November 18, 2019

TO	:	All Bidders
FROM	:	Mark Graham
PROJECT	:	Barton Elementary School Modernization
		Project 1720100.41
SUBJECT	:	Addendum 1
DSA	:	04-118157 / File 36-55

I	INTERIOR ELEVS AND ENLARGED PLANS		
	DRWN:	JY	ADD-01
	CHKD:	SJ	
	DATE:	11/14/19	
	SCALE:	1/4" = 1'-0"	SK5
	JOB NO:	1720100

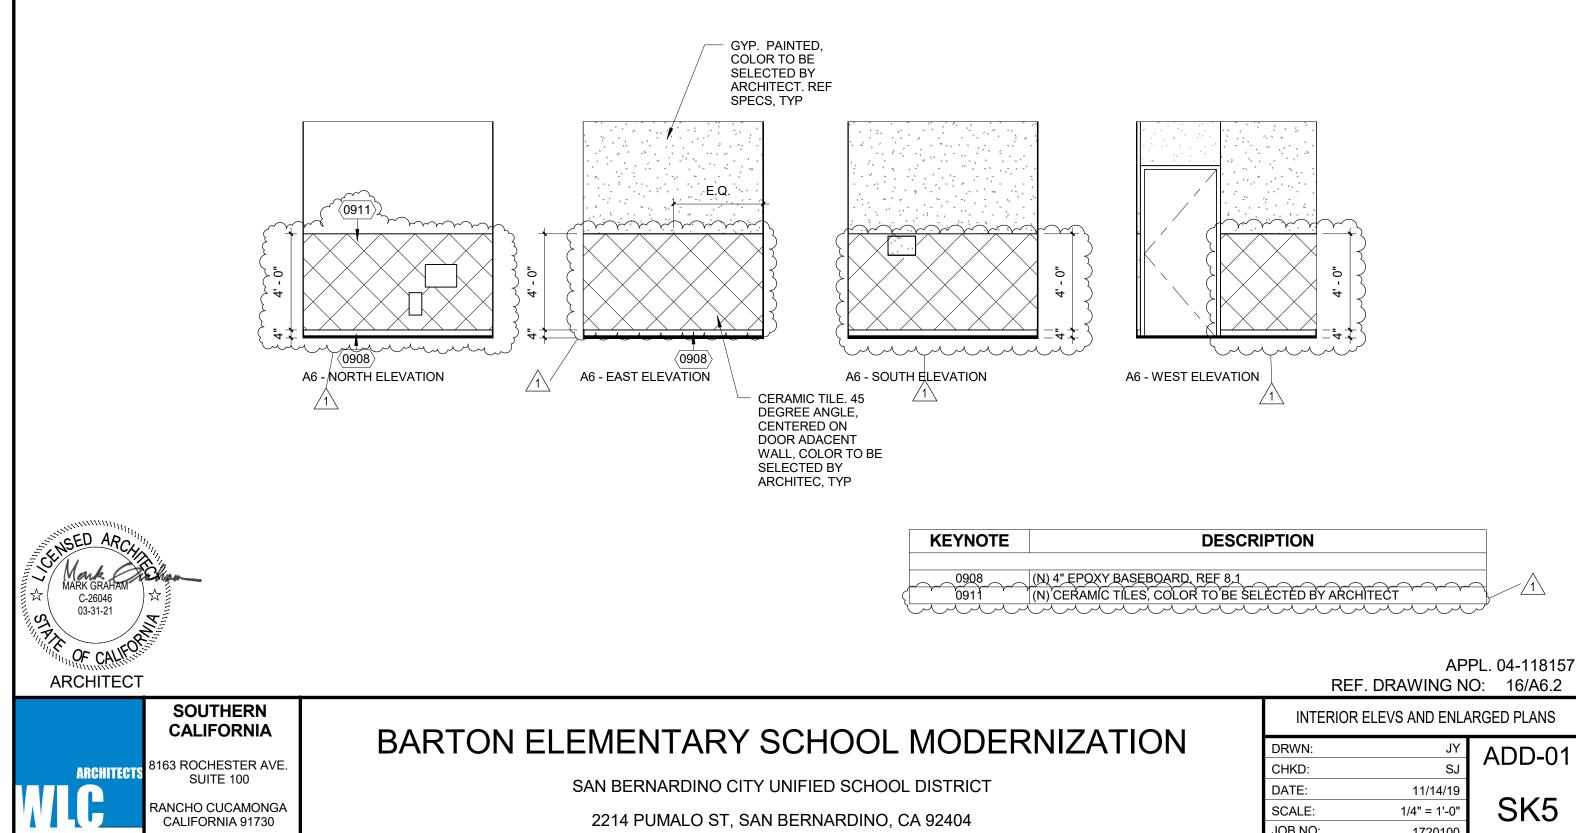
- 1.37 DRAWING A6.2
 - A. Revise wall tile layout. Replace Detail 15 with attached SK4.
 - B. Revise wall tile layout. Replace Detail 16 with attached SK5.

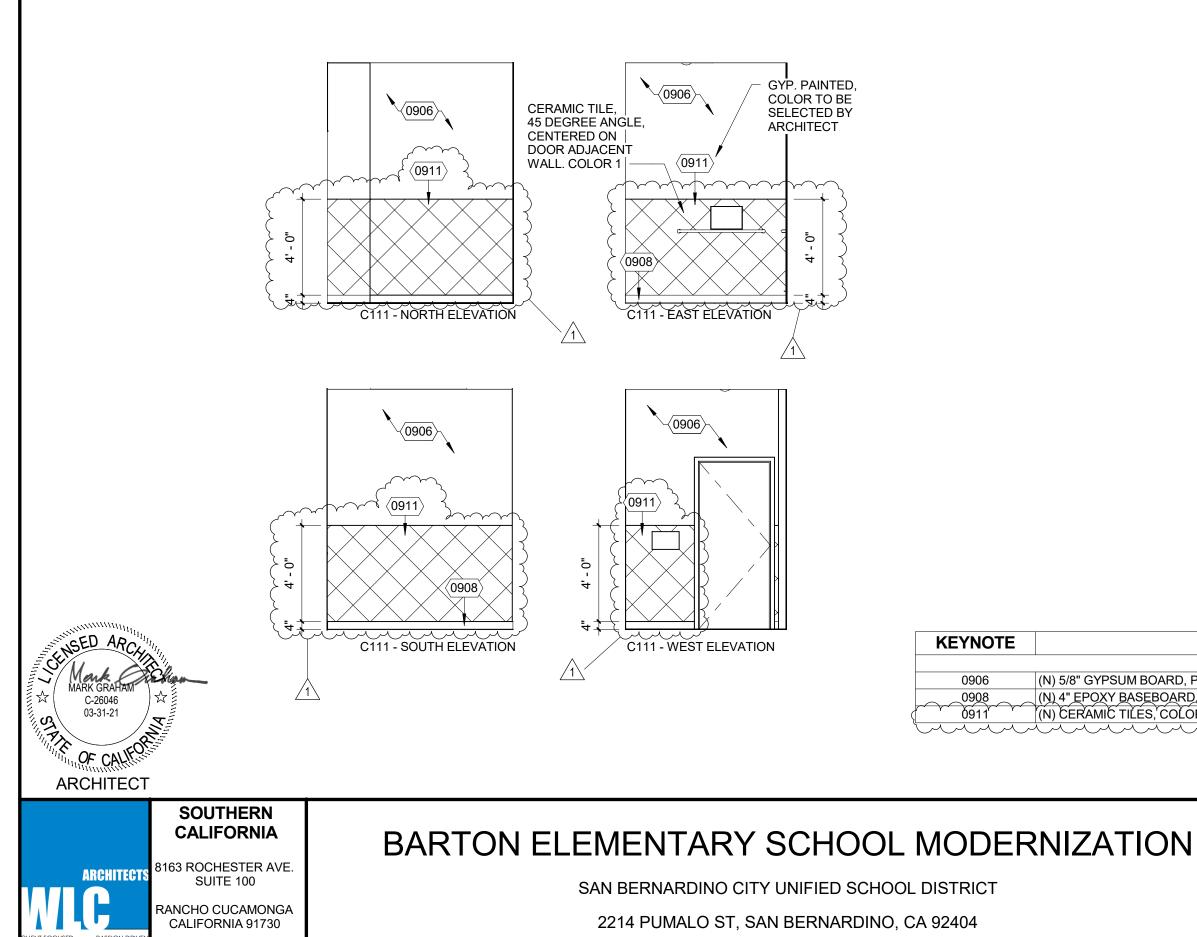
- C. Revise wall tile layout. Replace Detail 24 with attached SK6.
- 1.38 DRAWING A7.1
 - A. Detail 4
 - 1. Relocate section callout to new location. See attached SK7.

APPL. 04-118157 **REF. DRAWING NO:** 10/2.1

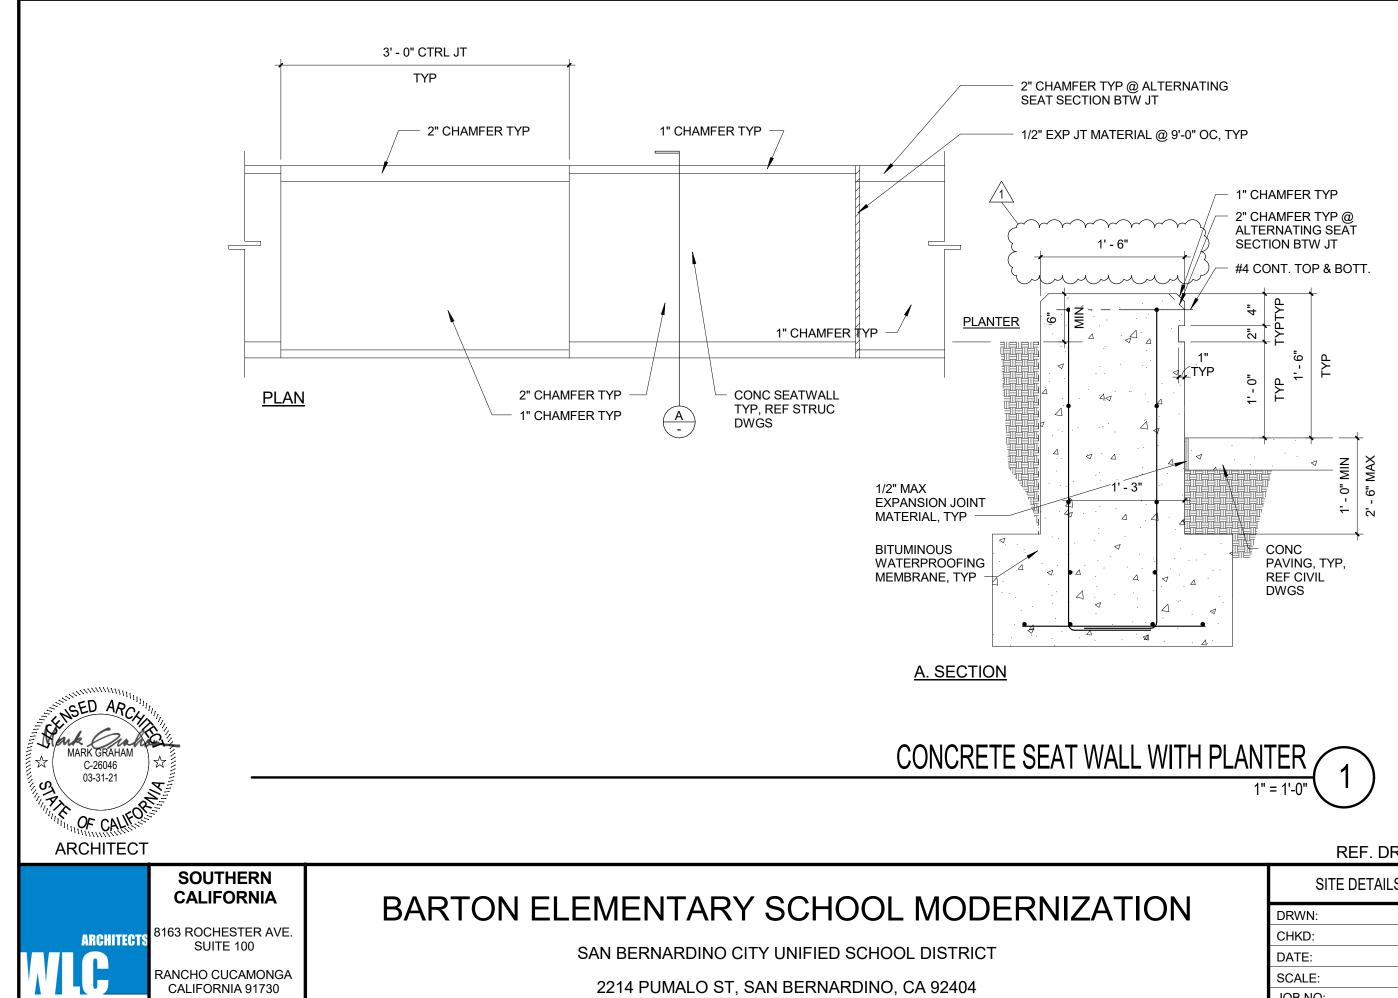
- C. Detail 3
 - 1. Replace with attached SK8 for new glass colors.
- 1.40 DRAWING 2.1
 - A. Detail 10
 - 1. Add dimension width for top of seat wall to be 18". See attached SK9.
 - 2. Revise drip edge and break MTL cover. See attached SK10.
- 1.41 DRAWING 6.1
 - A. Detail 1
 - 1. Revise Note 9 from "Dimesions" to "Dimensions".

MECHANICAL DEMOLITION ROOF PLAN - BUILDING A

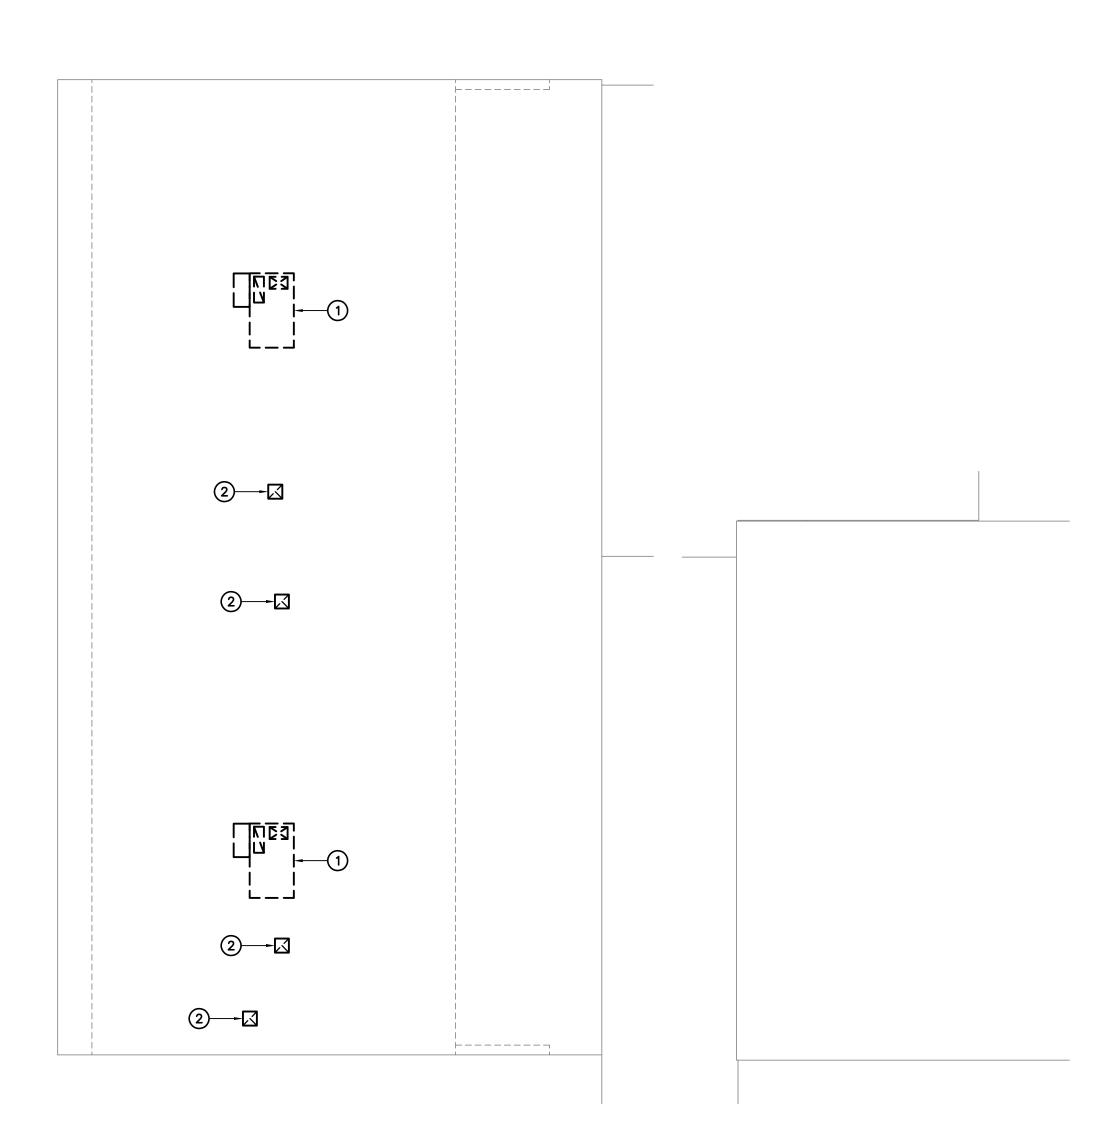
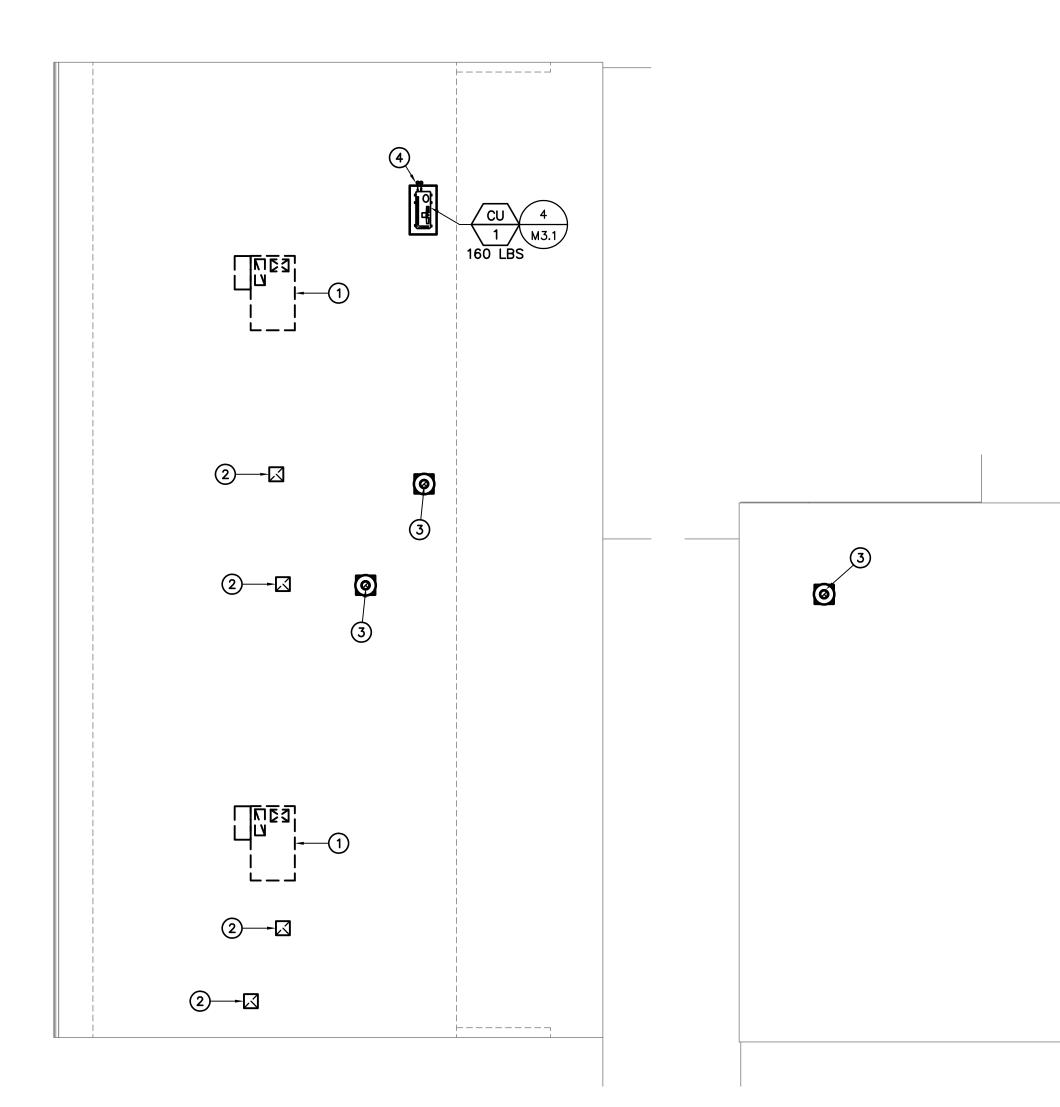
- 1.46 M2.1 (Refer to clouded areas on attached drawing)
 - A. Refrigerant piping penetration location relocated.
 - B. Condensing Unit CU-1 now shown on newly added attached Roof Plan Drawing M2.2.
 - C. Existing return grille relocated to correct location.
 - D. Door louver added to Toilet C108A. Keynote 7 also added indicating this.
 - E. Additional comments added to Keynote 2 for clarification.
 - F. Duct size through roof revised on Keynote 3.
 - G. Keynote 4 was removed.
- 1.47 M2.2 (Refer to clouded areas on attached drawing)
 - A. Add this new attached Drawing M2.2 in its entirety.
- 1.48 M3.1 (Refer to clouded areas on attached drawing)
 - A. Additional notes on Detail 4/M3.1 have been added for clarification.

BUILDING A FOUNDATION PLAN & BUILDING C PARTIAL FOUNDATION PLAN SCALE: 1/8" = 1'-0"

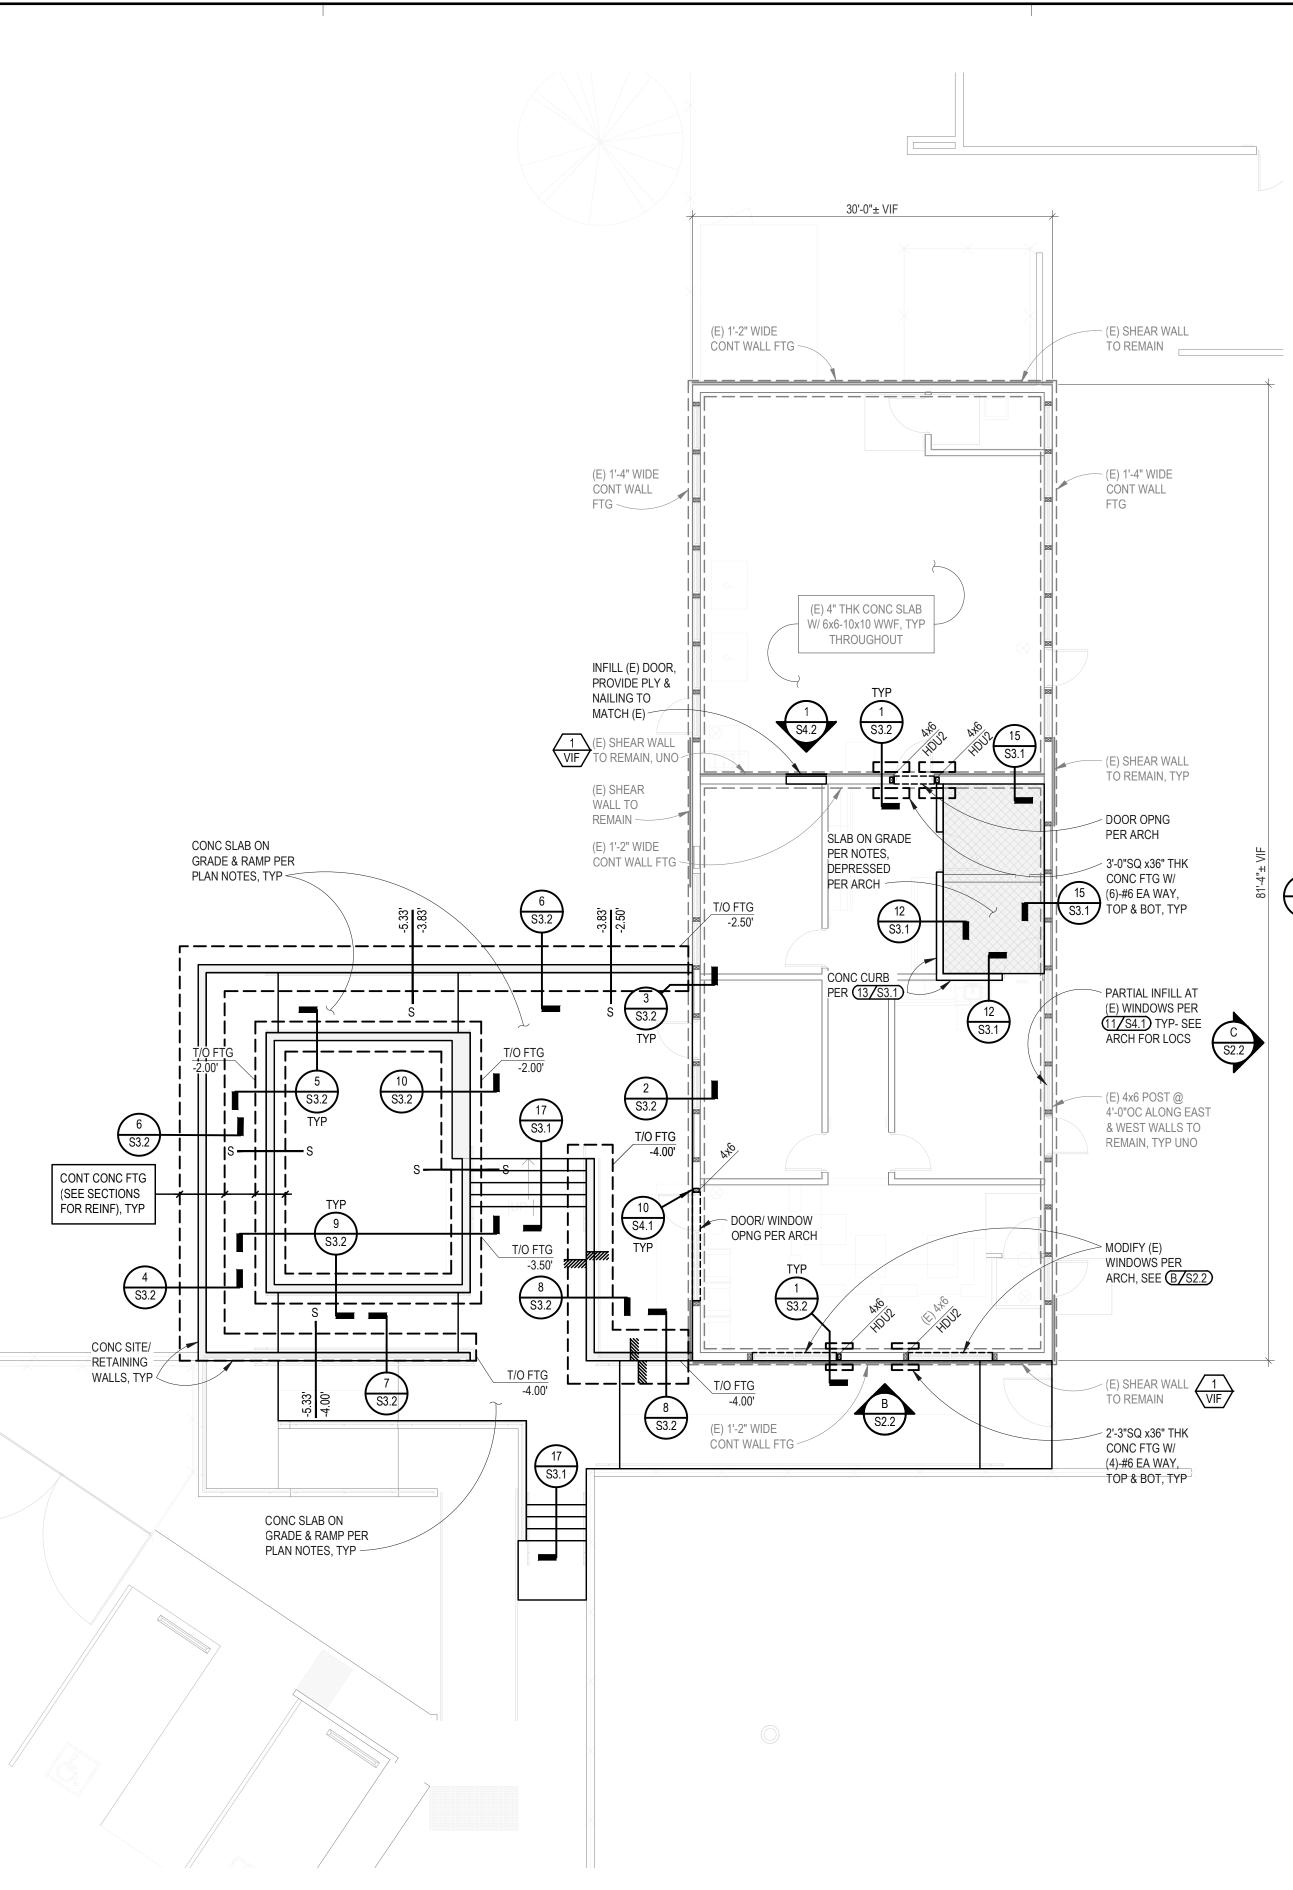
- 1.44 DRAWING S2.1 BUILDINGS A AND C FOUNDATION PLANS
 - A. Delete this drawing in its entirety and replace it with the attached Drawing \$2.1.
- 1.45 DRAWING S2.2 BUILDINGS A AND C ROOF PLANS AND ELEVATIONS
 - A. Delete this drawing in its entirety and replace it with the attached Drawing \$2.2.
